CONWAY  
HISTORIC DISTRICT COMMISSION  
JULY

## CONWAY HISTORIC DISTRICT COMMISSION MEETING

**OLD CONWAY DESIGN OVERLY DISTRICT  
CERTIFICATE OF APPROPRIATENESS  
SOWELL/JOHNSTON NEW RESIDENCE  
1425 MCKAY AVENUE**

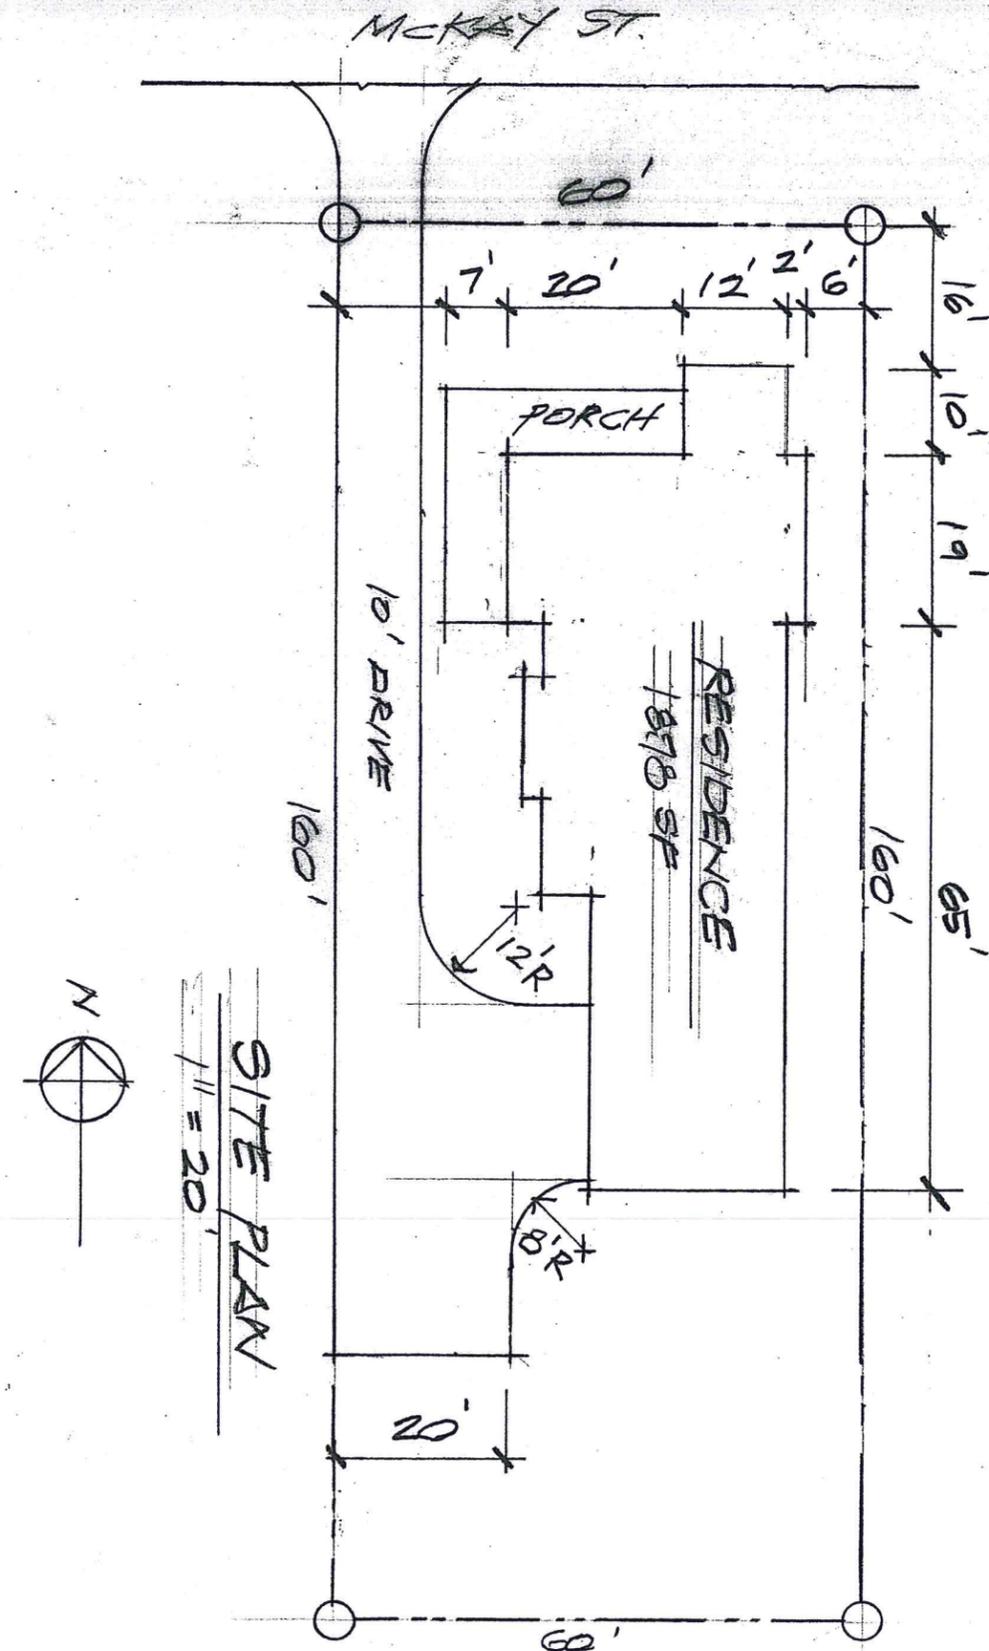
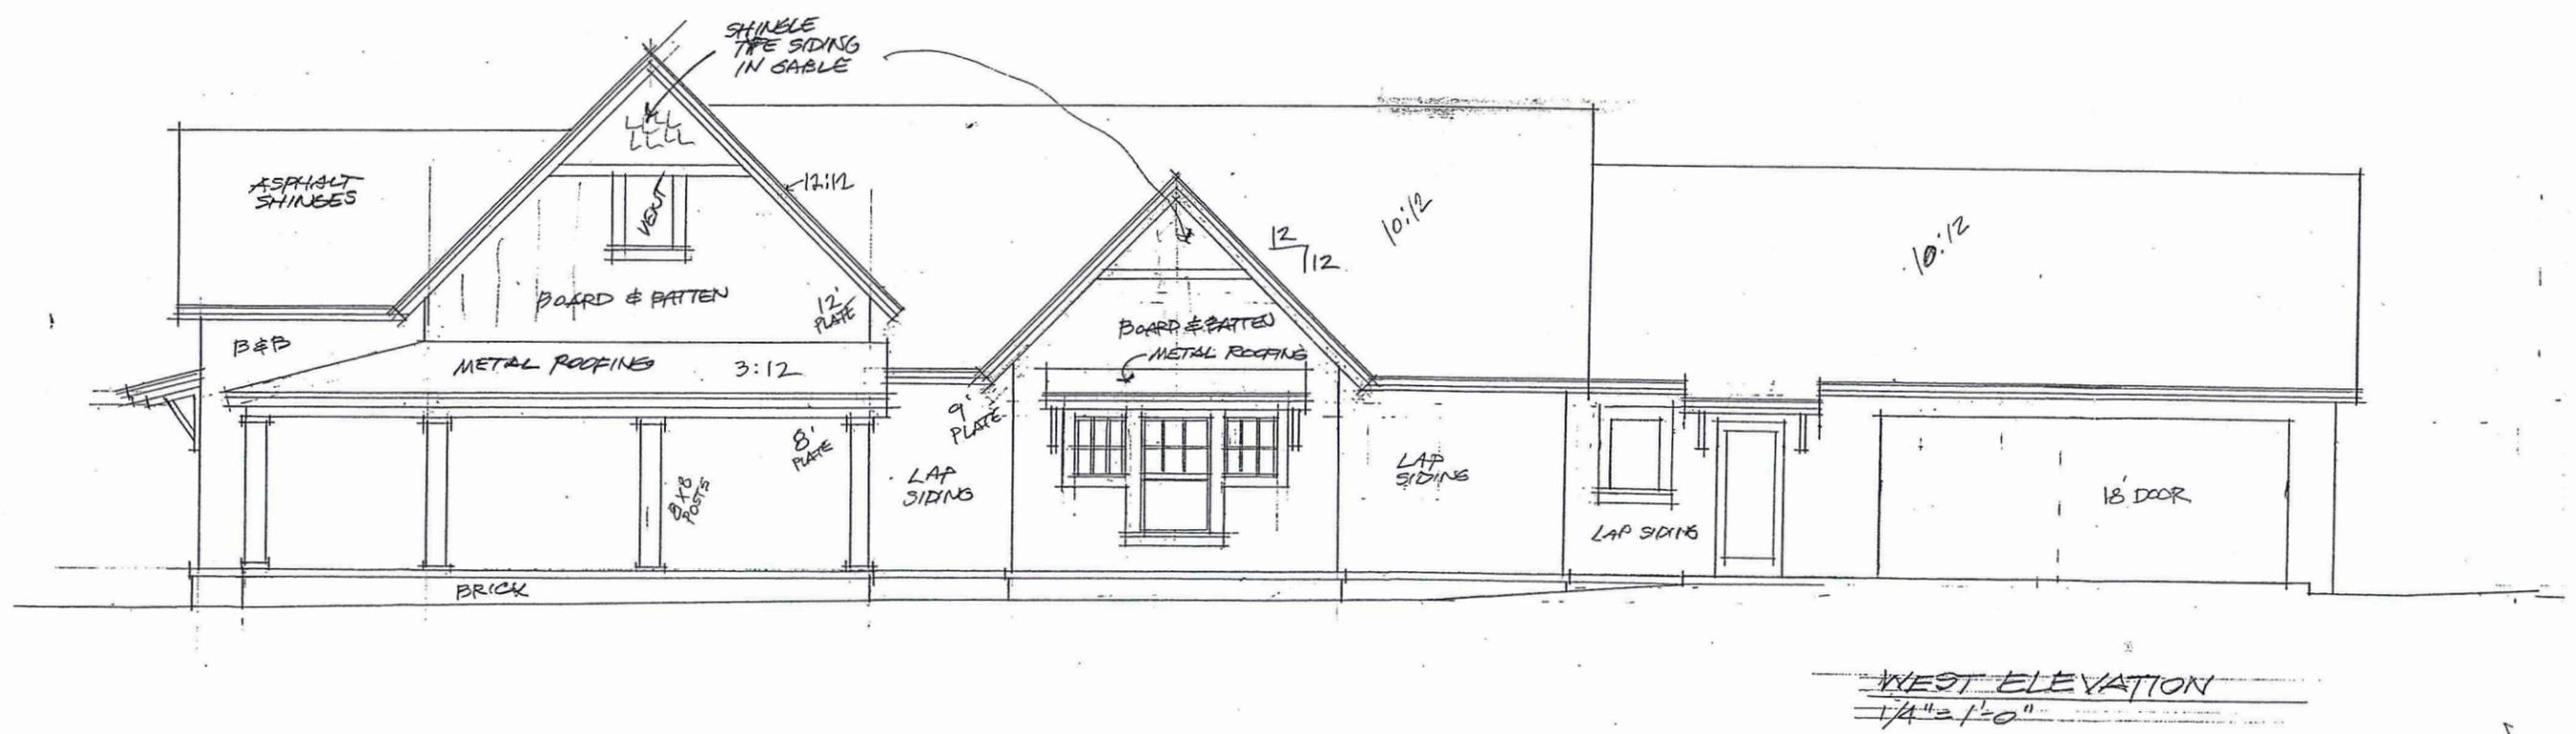
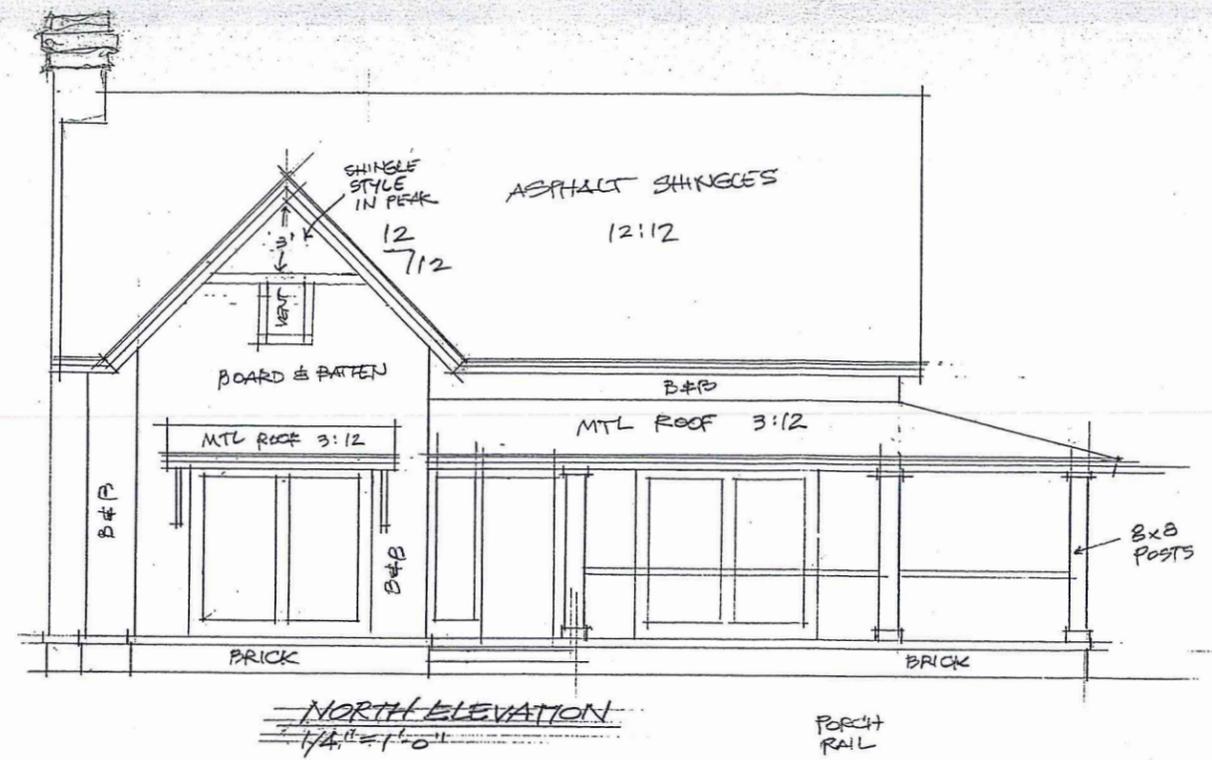
**Entries, Porches, and Porticos.** The front facade features a wrap around porch with a metal roof. The porch appears to be well over the required 6 foot minimum depth. Porch columns are shown as 8" x 8". The porch and columns are appropriate.

**Doors and windows.** The rhythm, patterns, and ratio of voids to solids of new buildings should relate to and be compatible with adjacent facades; typically a higher proportion of voids to wall area. The residence has quite a large area of glass on the front facade. Only two elevations were submitted. It is assumed that additional windows and doors will be placed on the west elevation in the porch area. The applicant can address the number of windows and doors on all elevations at the meeting.

**Awnings.** When new construction uses awnings, traditional awning designs, materials, and placement should be used. Awnings are shown above two window areas. These awnings have metal roofs and wooden brackets and are appropriately traditional in nature.

It is assumed that the residence will be clad with fiber cement siding. Vertical board and batten siding is shown on the majority of the structure. Accent lap siding and shingle siding are also used. A brick base is shown. These materials and are appropriate.

**Roof.** An asphalt shingle roof is proposed for the majority of the residence. A standing seam metal roof is shown above the porch and used on window awnings.

1. The residence and driveway shall be constructed as shown in submitted plans.
2. Fiber cement siding shall be used.
3. The driveway shall be constructed of concrete as shown.
4. Windows?
5. A sidewalk must be constructed along McKay Avenue or an lieu fee of \$600 must be paid into the sidewalk fund. City Engineer and Planning Director may determine if an in-lieu fee is appropriate

Applicant provided sketch of proposed modifications

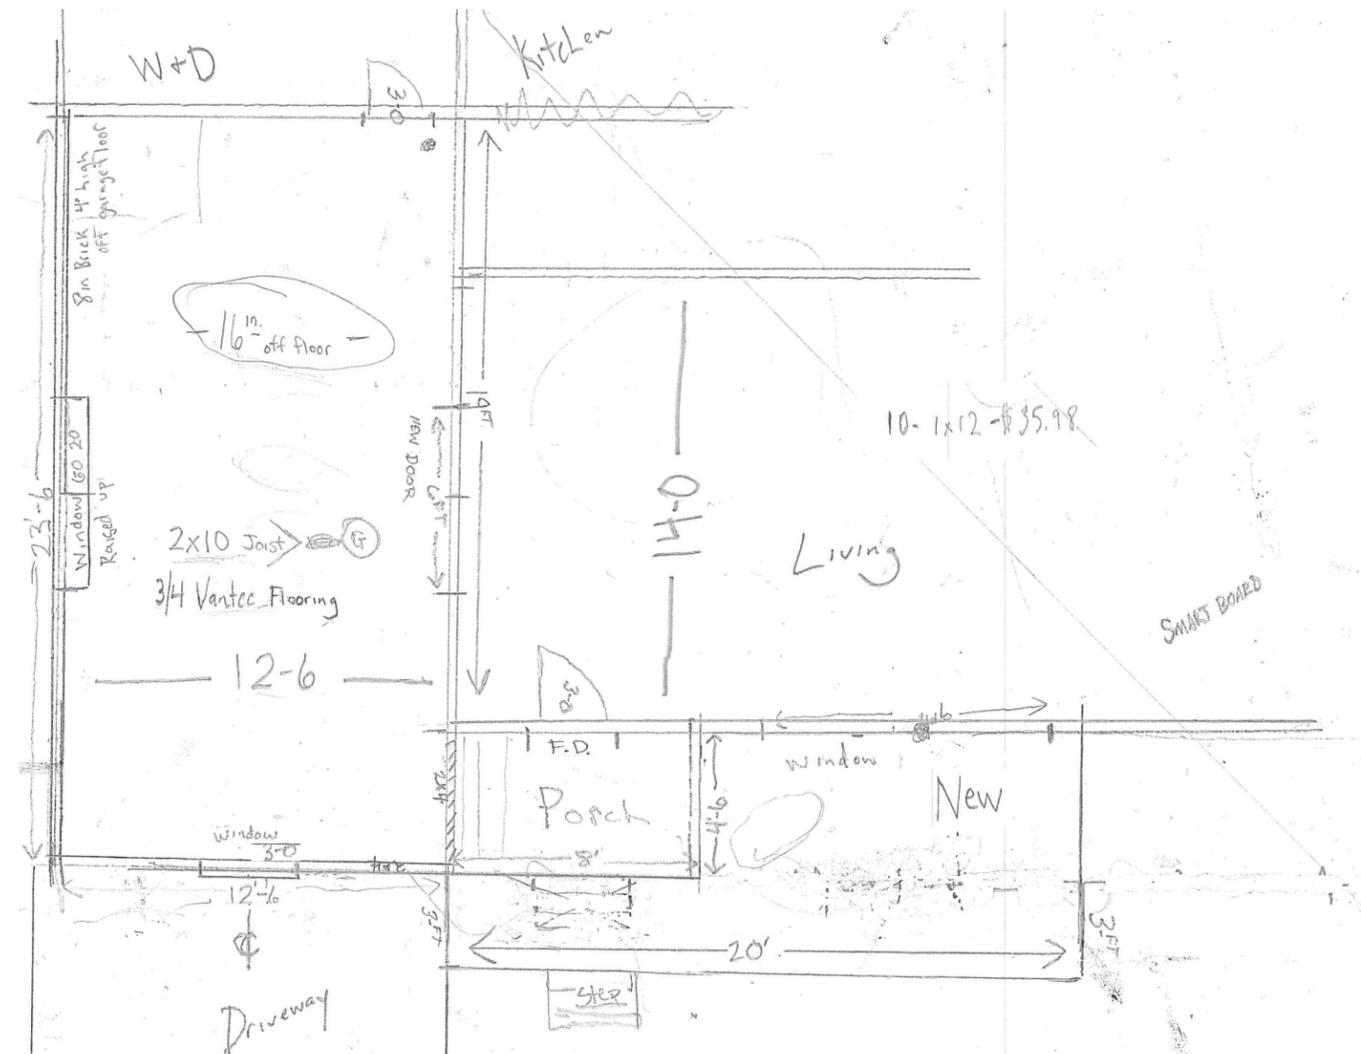
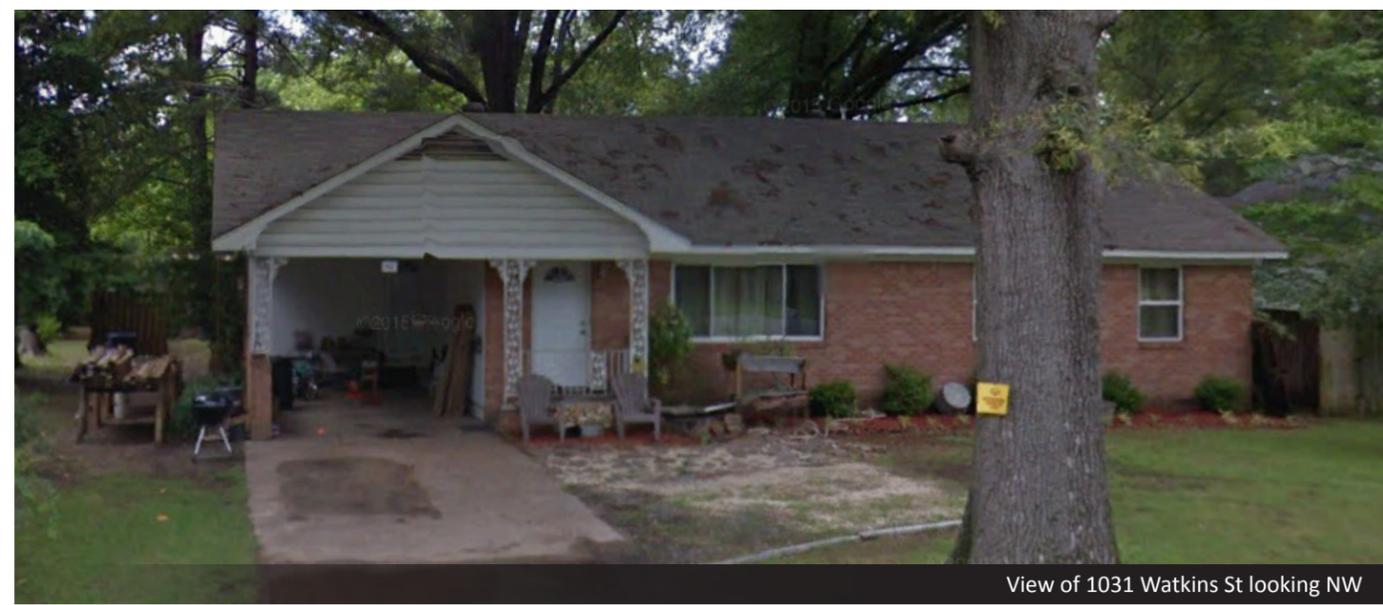
**Entries, Porches, and Porticos.** The front facade entry area will change slightly. The enclosure will extend out to the edge of the existing front entry stoop. This also lines up closely with front of the carport gable. A new wooded porch or deck area will be added enlarging the stoop's area. Steps will be added to this porch directly in front of the front door. The applicant would also like to replace the wrought iron columns with cedar wood columns.

**Doors and windows.** The rhythm, patterns, and ratio of voids to solids of new buildings should relate to and be compatible with adjacent facades; typically a higher proportion of voids to wall area. The residence has the typical number of doors and windows of a ranch style home. The enclosure will include a new 3'-0" wide window on the front facade and a double window on the south facade.

**Architectural Details, Siding, and Bricks.** Eaves, brackets, dentils, cornices, molding, columns, trim, etc. The residence appears to have brick siding with the exception of the carport area which appears to have wood siding. There is a short brick wall on the south side of the carport. The applicant would like to keep this brick wall and add an enclosure wall to the top of the bricks. The enclosure area siding is proposed to be clad with vinyl siding.

1. The carport enclosure and porch addition shall be constructed as shown in submitted plans.
2. Vinyl siding shall be allowed on the enclosure walls.
3. Porch columns minimum of 8 inches in width.
4. Low brick wall may be incorporated into the south side carport enclosure wall with Building Inspector approval.

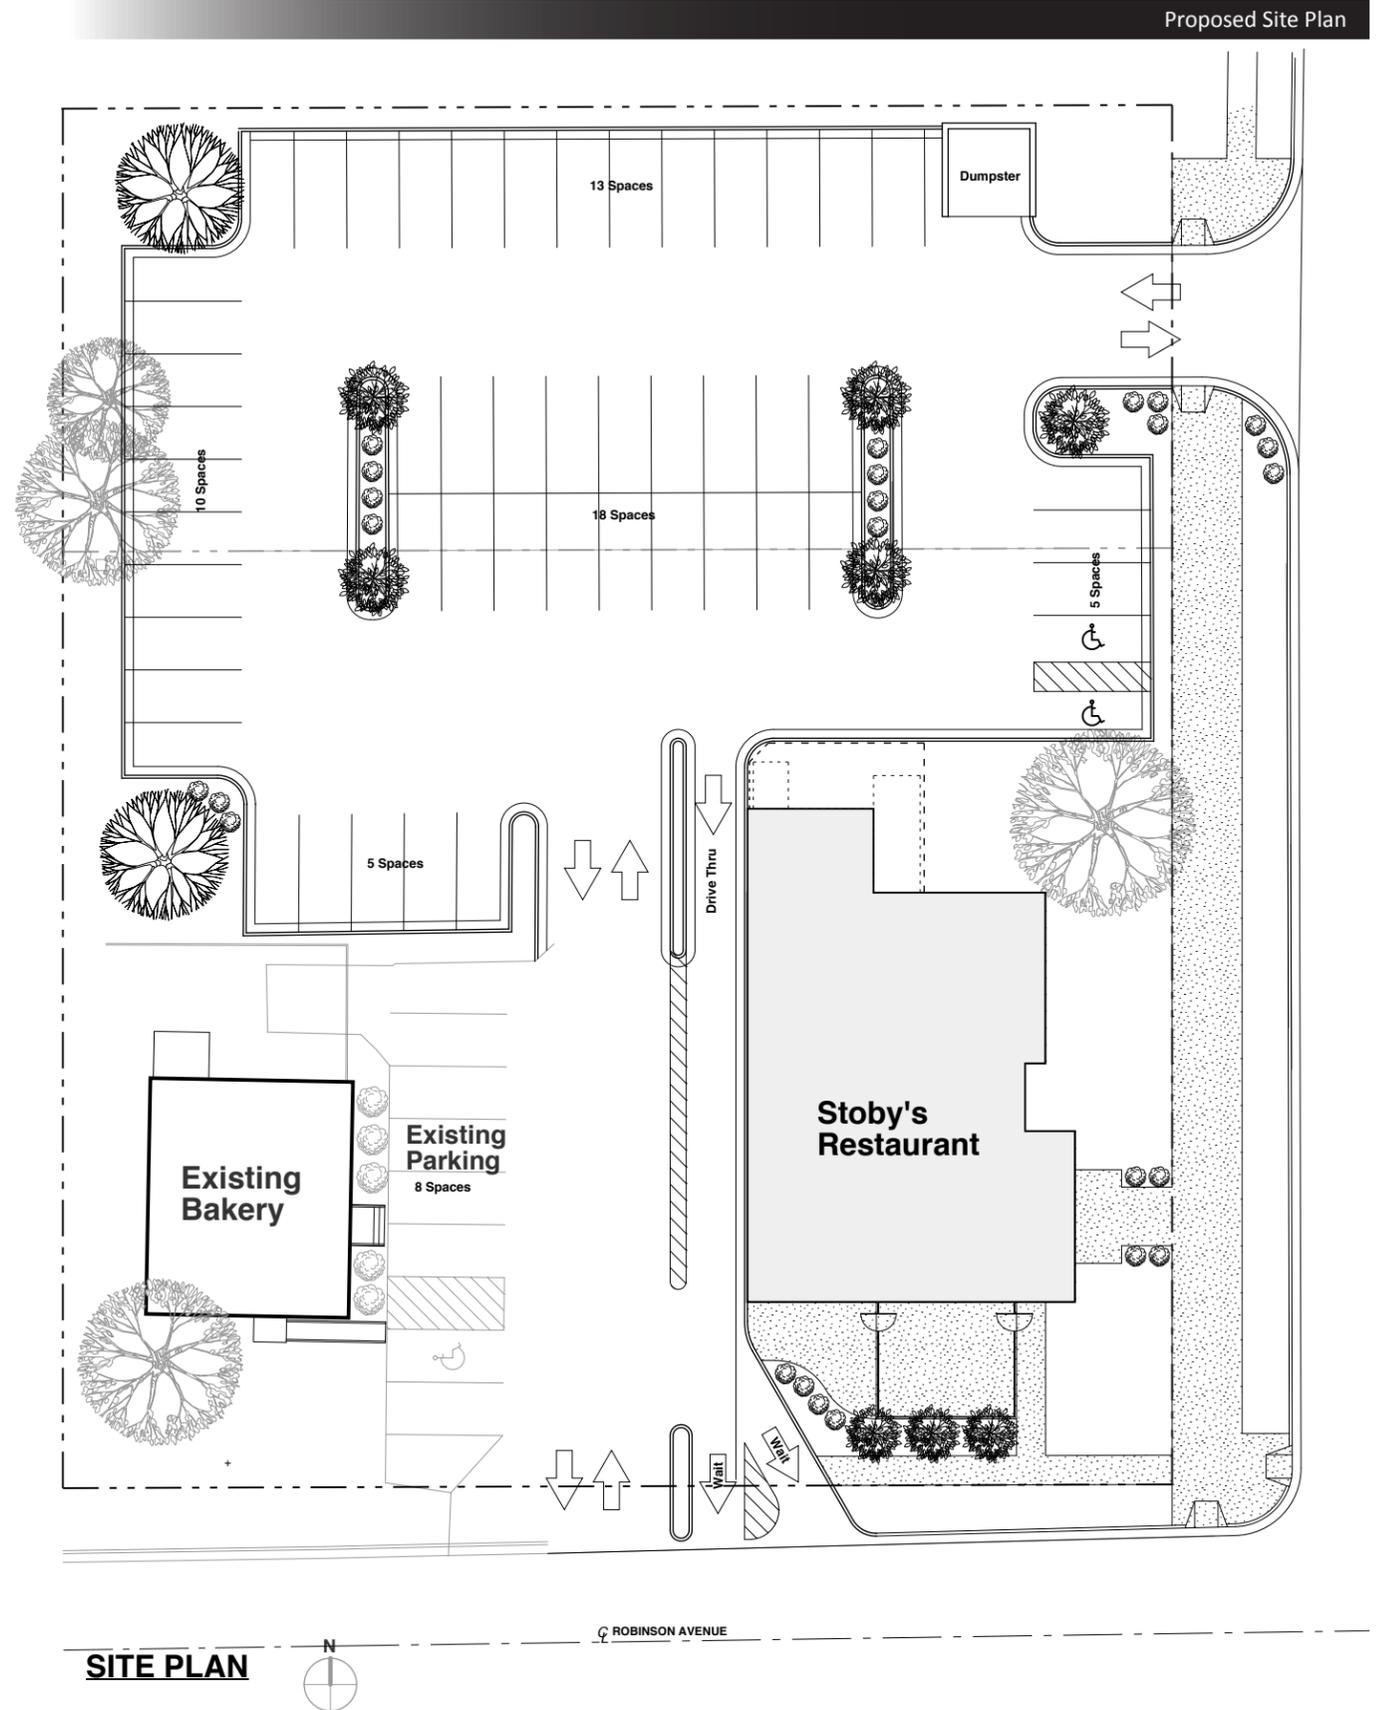
**Driveway/Parking.** The existing driveway and parking area is not an ideal situation as it was created over the years as Stoby's popularity increased and land became available. The existing parking from Robinson and Donaghey is a continuous curb cut. This will be replaced with a wide sidewalk and landscaping. Well defined curb cuts will be placed on the north side of the property on Donaghey and the middle of the property on Robinson. The pickup window and drive aisle are moved to the rear. This new vehicle circulation pattern will present a much better traffic flow. Additional landscaping or a low wall will be needed along Donaghey to screen the parking area.

**Fences.** There appears to be a fenced area on the south side of the new restaurant. The applicant can give more details at the meeting.

**Mechanical Screening.** HVAC units should be visually located away from streets or screened by landscaping. Exterior HVAC ductwork should not be visible from the street. HVAC equipment location is not shown on the site plan.

1. The restaurant and parking area shall be constructed as shown in submitted plans.
2. Siding shall be Hardiboard or similar cement siding.
3. Additional windows or detailing on the west elevation?
4. Screening of the parking spaces along Donaghey is required with landscaping or a low wall.
5. HVAC units shall be visually located away from streets or screened by landscaping.

**WEST ELEVATION**  
1/4"=1'-0"

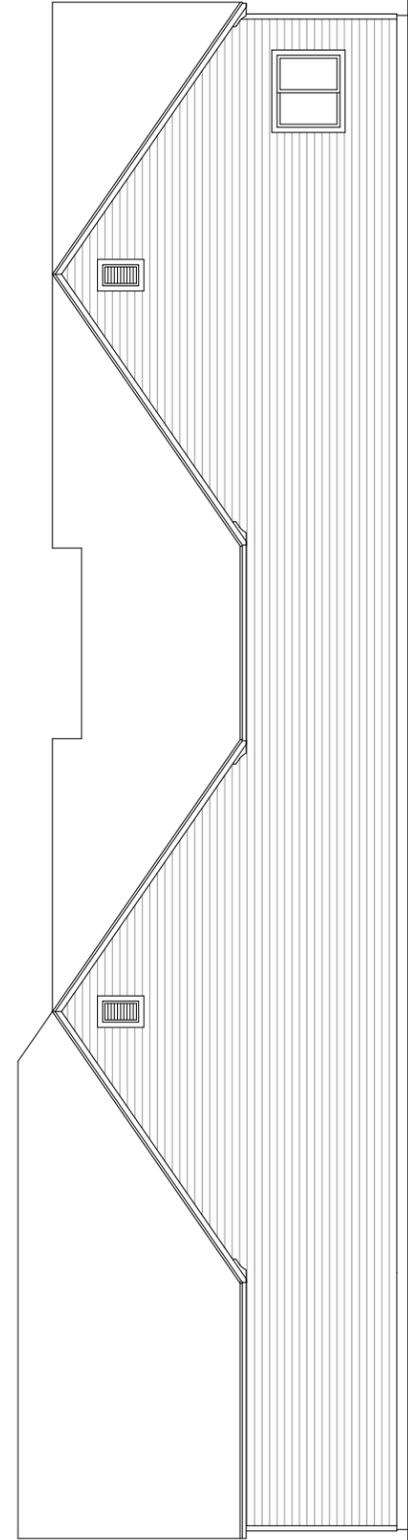
**Façade, wall area, rhythm.** Facades shall be compatible with surrounding historic structures in proportion of wall to opening area. The new restaurant has retained the original appearance with gables and window locations. Original window and gables have been mimicked in the additional dining area on the north side. Additional windows have been added to the north and south elevations. The west elevation is blank with the exception of the pick up window. This wall will be the kitchen and prep areas and is largely hidden from the public view. Additional windows or detailing could be added to this elevation if possible.
